Remarks and Arguments in Favor of Patentability

Amendments to the Drawings:

Fig. 4B

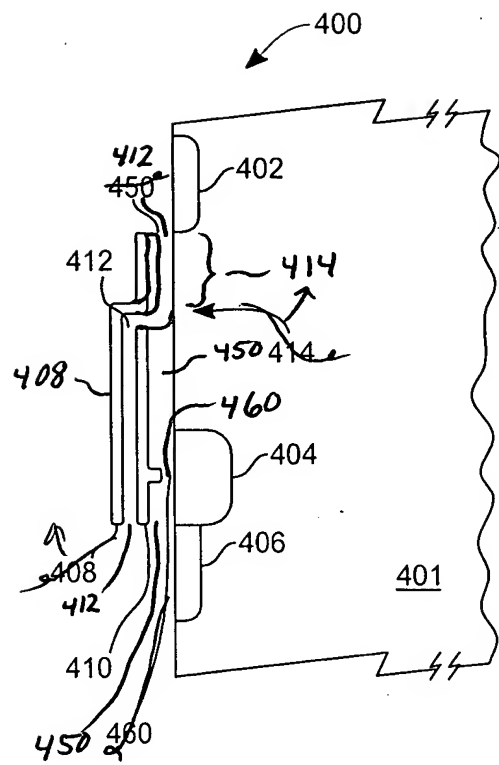
Applicant is amending Fig. 4B by adding and/or relocating labels for clarification and closer correspondence to Fig. 5G. Additions and changes are shown in red on the attached copy of Fig. 4B. Each label noted in red is either a relocation and/or copy of a previously used label or is used in paragraphs explaining these figures in the specification.

The label for gate ONO layer 450 is moved to better correlate with corresponding initial gate oxide layer 517 of Fig. 5E. The active region 414 is shown with a brace to better delineate its range. The interpoly layer 412 is now labeled at each extent between source implant region 406 and drain implant region 402. A line of delineation has been added between the gate ONO layer 450 and the inter poly layer 412 at the end of the floating gate 410, closest to the drain implant region 402, which extends down to the substrate surface. This matches with the previous representation of the corresponding interpoly dielectric layer 521 in Fig. 5G. Applicant avers that no new matter has been added as a result of the aforementioned changes.
